STAFF RECOMMENDATION
3726 Richland Avenue
April 20, 2016

Application: Demolition; Reconstruction
District: Richland-West End Neighborhood Conservation Zoning Overlay
Council District: 24
Map and Parcel Number: 10409007300
Applicant: Gary and Lou Ann Brown
Project Lead: Paul Hoffman, paul.hoffman@nashville.gov

Description of Project: Demolition of a contributing building and reconstruction to the specifications and details of the existing building.

Structural Condition Assessment of 3726 Richland Ave., Nashville, Tennessee

Figure 3. The front foundation wall is crumbling into the basement

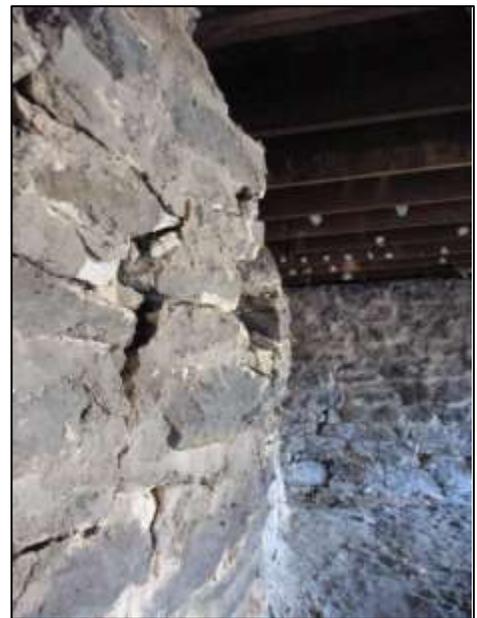
Demolition: There is settling apparent on first view of the building's front facade. The front porch shows a fall of two to three inches (2-3") over its twelve feet (12') from right to left. At an unknown date, the deterioration of the foundation wall was observed and remediation attempted with a new concrete block wall. This was laid adjacent to the front stone wall to a height of approximately seven feet (7') to support the stone wall. The new wall may have kept the stone behind it from fully collapsing. The engineer for the project observes that it also hid the problem, preventing the necessary repair:

In order to assess the condition of the front basement wall hidden by the newer block wall, The Maintenance Company excavated a portion of the backfill against the front wall. What we discovered is that the wall hidden by the block wall was crumbling. The portion of the front wall not hidden by the block bowed inward during excavation and cracked considerably. The excavator noticed that the wall moved during his work.

Consequently the stone wall requires rebuilding, while isolating the structure above. MHZC staff discussed with the applicants the possibility of phasing the repair work and rebuilding one section of the wall at a time. The engineer argues that is not feasible:

crumbled front basemen wall behind block

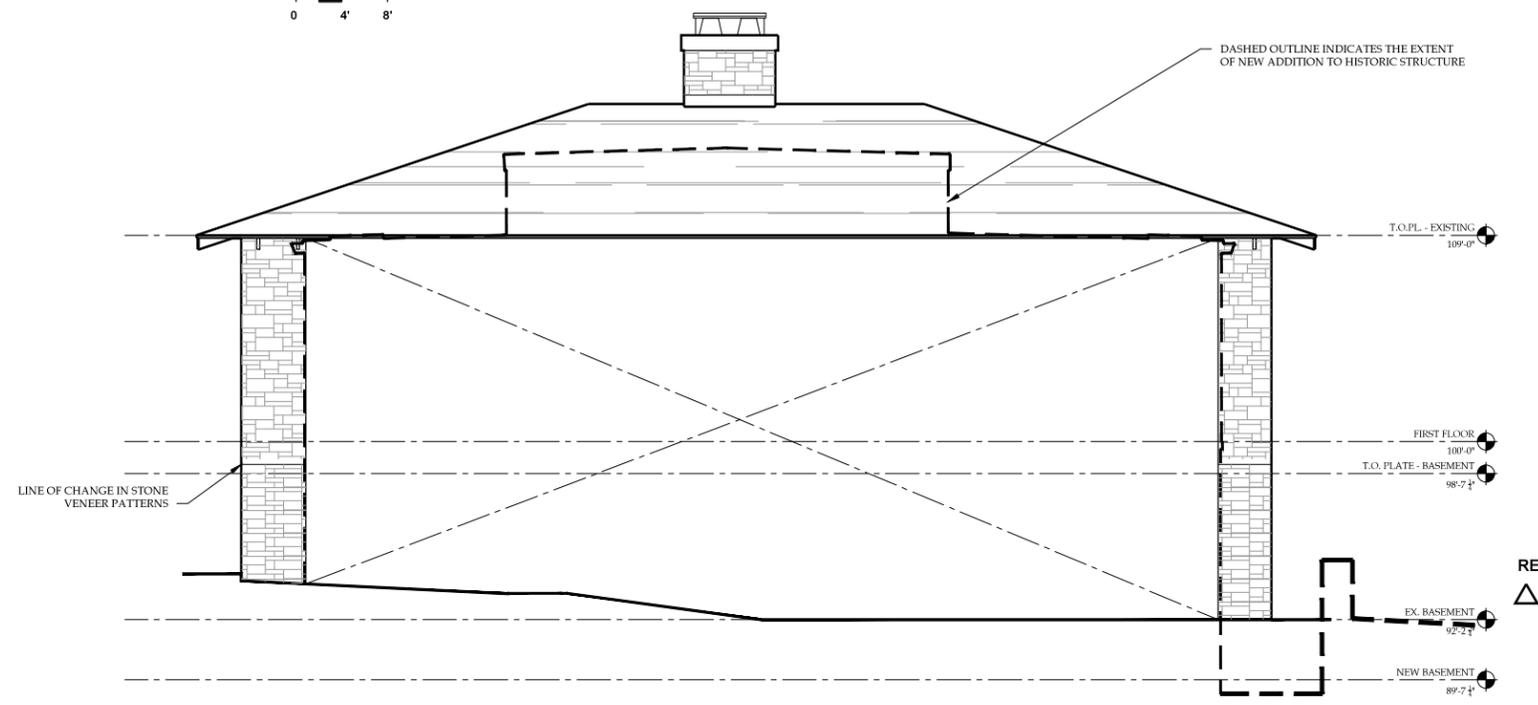
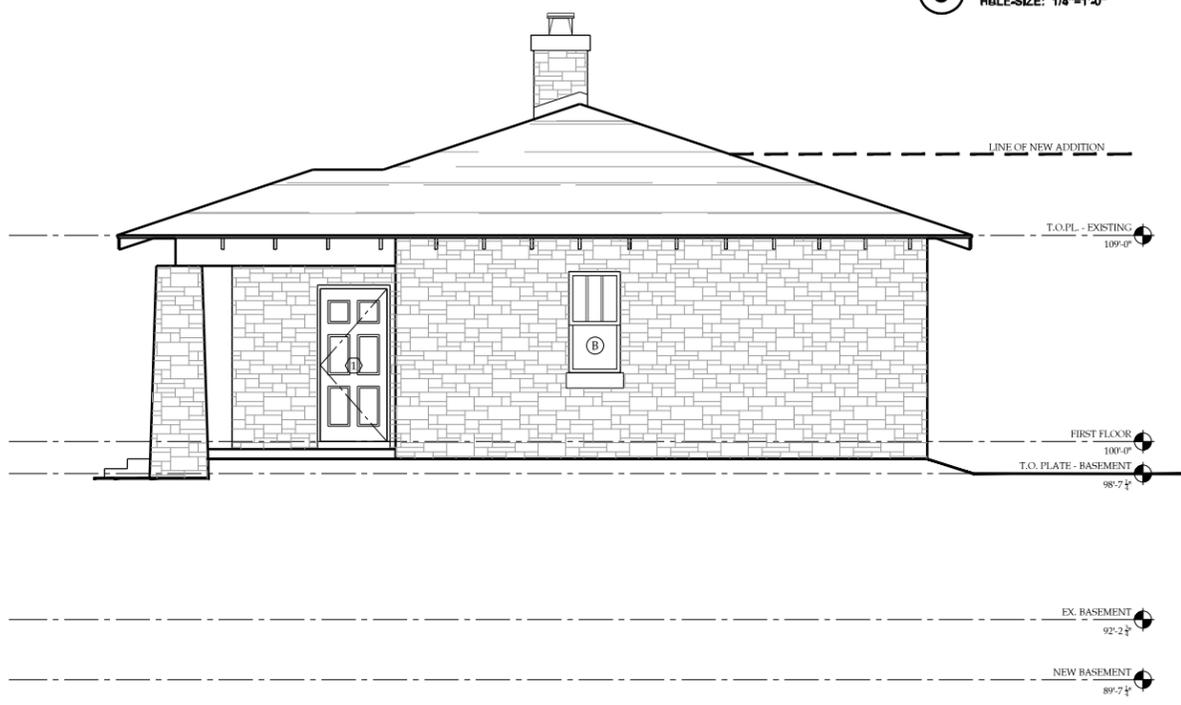
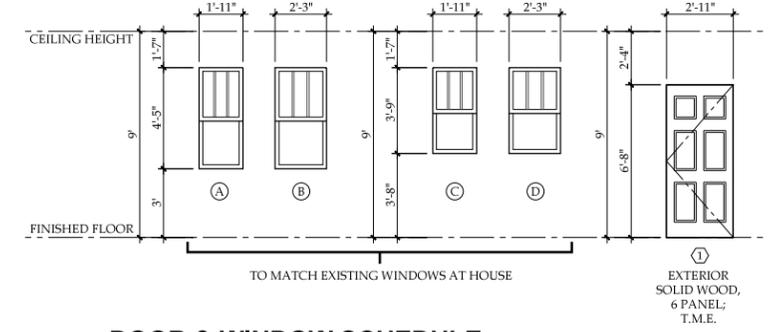
What we discovered is that the wall hidden by the block wall was crumbling.

The portion of the front wall not hidden by the block bowed inward during excavation and cracked considerably. The excavator noticed that the wall moved during his work.

The bulge in the wall was more pronounced at a later site visit, indicating that it is moving and is unstable.

Based on what we have discovered, the condition of the front stone wall, and the construction of the walls, it is my recommendation to demolish the house and re-build it.
